CITY OF ALBUQUERQUE

October 8, 2025

Re: Arby's
6110 San Mateo Blvd NE
Traffic Circulation Layout
Architect's Stamp 09-08-25 (E18-D056)

The TCL submittal received 09-08-2025 is approved for Building Permit by Transportation. A copy of the stamped and signed plan will be needed for each of the building permit plans. Please keep the original to be used for certification of the site for final C.O. for Transportation.

ARCHITECTURAL SITE PLAN - TCL
SCALE: 1" = 20'-0"

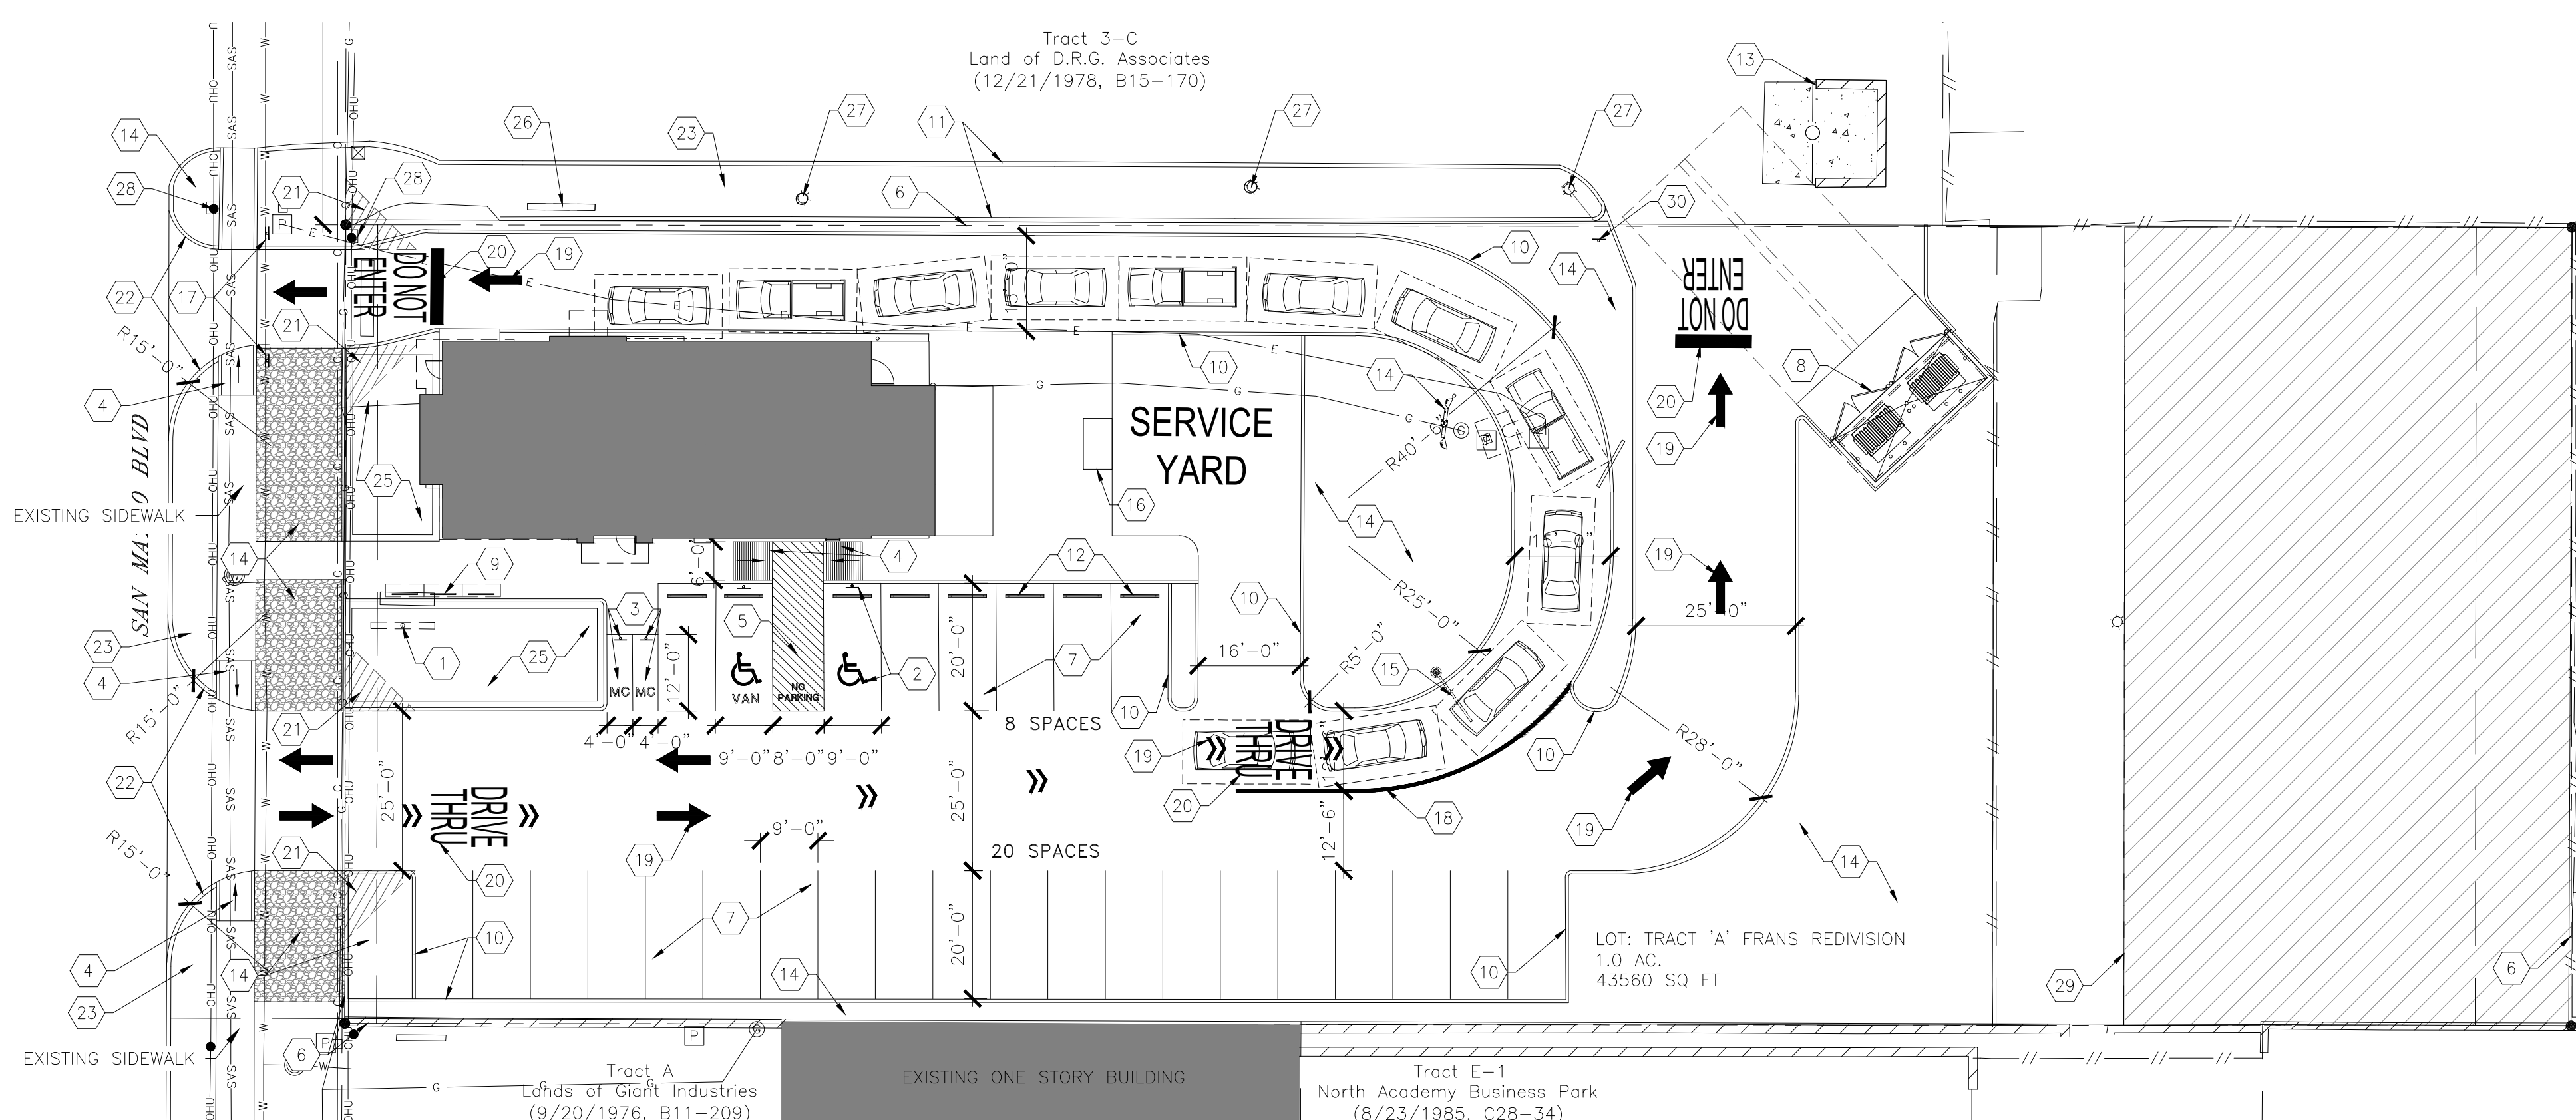
When the site construction is completed and an inspection for Certificate of Occupancy (C.O.) is requested, use the original City stamped approved TCL for certification. Redline any minor changes and adjustments that were made in the field. A NM registered architect or engineer must stamp, sign, and date the certification TCL along with indicating that the development was built in "substantial compliance" with the TCL. Submit this certification, the TCL, and a completed Drainage and Transportation Information Sheet to ABQ-Plan for log in and evaluation by Transportation. **AN APPROVED ACROSS ACCESS EASEMENT AND AN APPROVED REVOCABLE PERMIT ARE CONDITIONS FOR RELEASING THE FINAL CO.**

**AN APPROVED ACROSS ACCESS EASEMENT AND AN APPROVED
REVOCABLE PERMIT ARE CONDITIONS FOR RELEASING THE FINAL CO.**
